UNITED STATES PATENT AND TRADEMARK OFFICE

10/694,463

Office Action Summary

DETAILED ACTION

FIG. 1

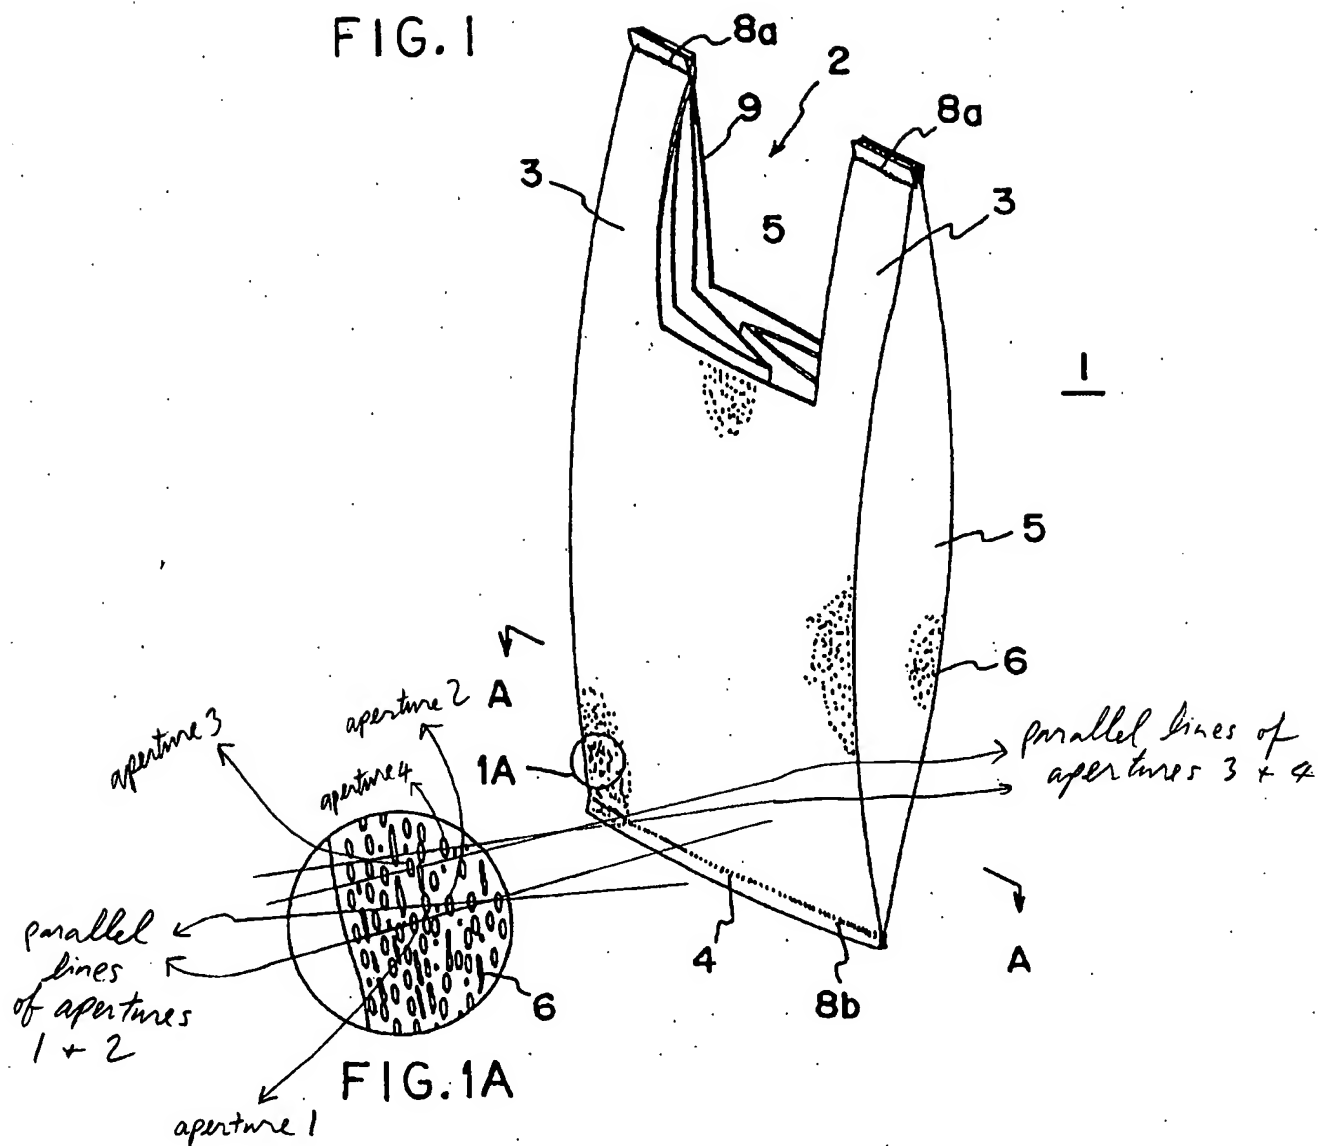
16. Applicant further argues that Takita does not disclose antiparallel orientation of the apertures, Applicant's argument is acknowledged. However, it is noted that Figure 1A (attached at the end of this office action) shows the antiparallel orientation (note that

the parallel lines of the apertures are crossed and therefore, it is anti-parallel oriented) of the apertures.
